## PRODUCT IMPROVEMENT BULLETIN

#241V

### Ventadome Handle Improvement

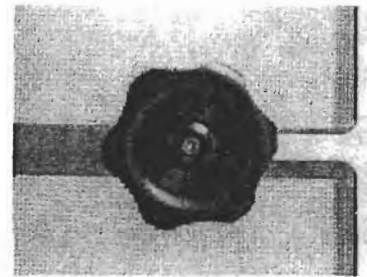
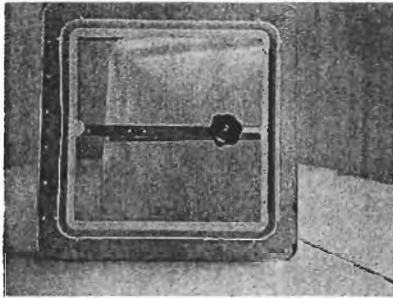
Ventline is changing the “L-shaped” crank handle on our standard roof ventadomes to the above pictured round knob. The round knob provides an easier grip and allows for a smoother operation of the lift assembly. Another benefit is the new knob detaches easily, permitting faster screen removal and cleaning.

The change to the round knob will occur in early summer as a running change. We will make every effort to have product rotated in all warehouses to alleviate customers receiving mixed product. Ventline will keep a stock of the VA0467-00 “L-shape” crank handle for replacement purposes. Of course, distributors, dealers and coach owners may upgrade to the round knob as the parts are interchangeable.
